Technical Bulletin

Reissued: 12-Mar-10 Model: AI-C1 LCIT PB3050

No.: RD352001c

Subject: Parts st	andardization		Prepared by: K. Hamada			
From: 1st Overse	as Tech Support Sec., 1st PQ	M Dept.				
Classification:	Troubleshooting	Part informat	tion	Action required		
	🗌 Mechanical	Electrical		Service manual revision		
	Paper path	Transmit/rec	eive	Retrofit information		
	Product Safety	Other ()	Tier 2

Guide Plate (B2232835 → D0092836) Note: As mentioned above, the Mylar was deleted.

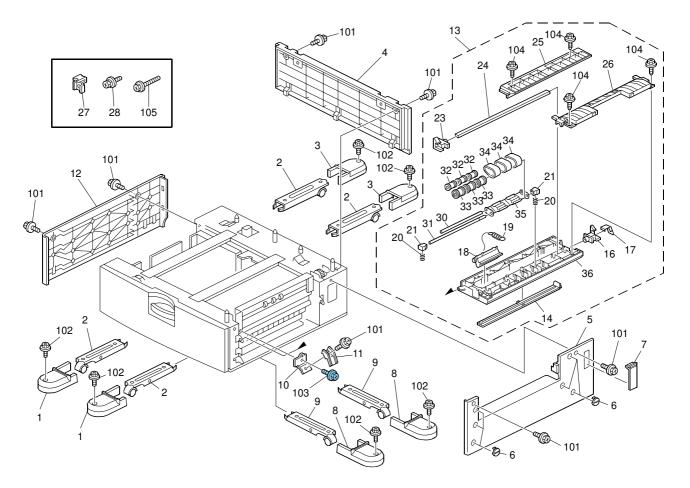
Note: The Mylar was deleted from the Guide Plate (see photo below).

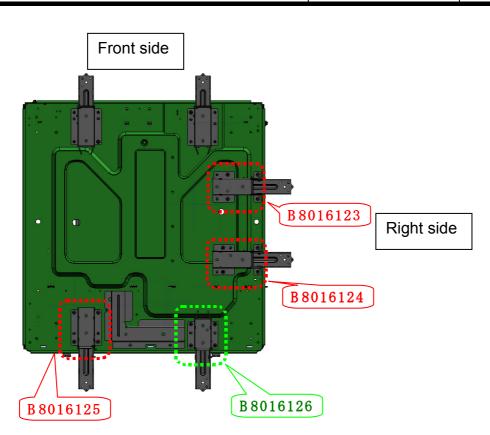
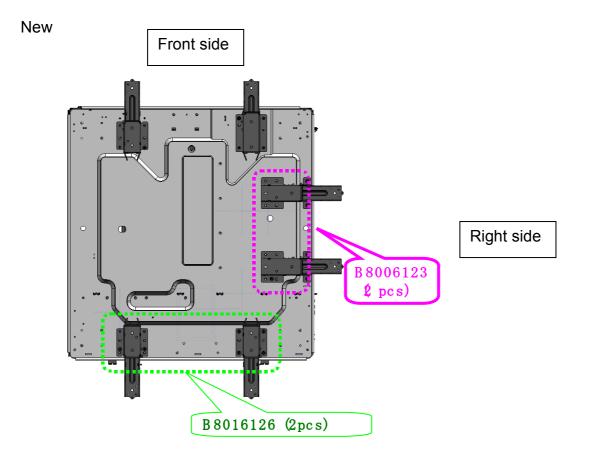
Old part	New part	Description	Q'ty	Int	Page	Index	Note
number	number						
B8011059	B8001059	Cover: Buring: Base	1-1	X/X	15	10	X/O
B8016123	B8006123	Bracket: Arm: Remove/insta	l: 1-2	X/X	5	15	as a
		Right					set
B8016124		Bracket: Arm: Remove/insta	l: 1-0	-	5	16	
		Right inner Rear					
B8016125		Bracket: Arm: Remove/insta	l: 1-0	-	5	18	
		Rear Right					
B801	6126	Bracket: Arm: Remove/insta	: 1- 2	-	5	17	
		Rear Left

Change/Reason: Part standardization

Please replace the above parts together as a set.

Parts Catalog Collection

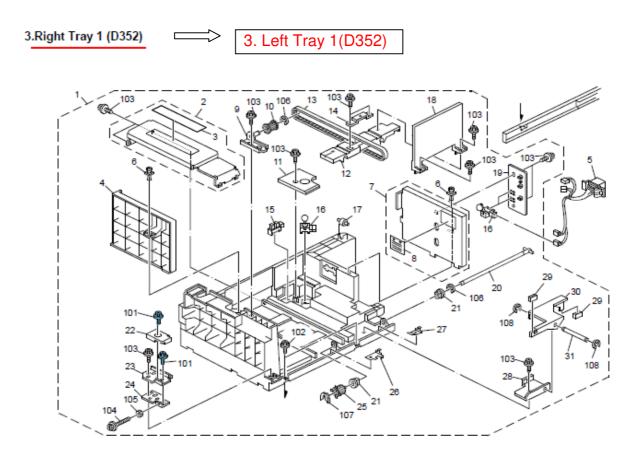
The following descriptions are modified as shown in red.
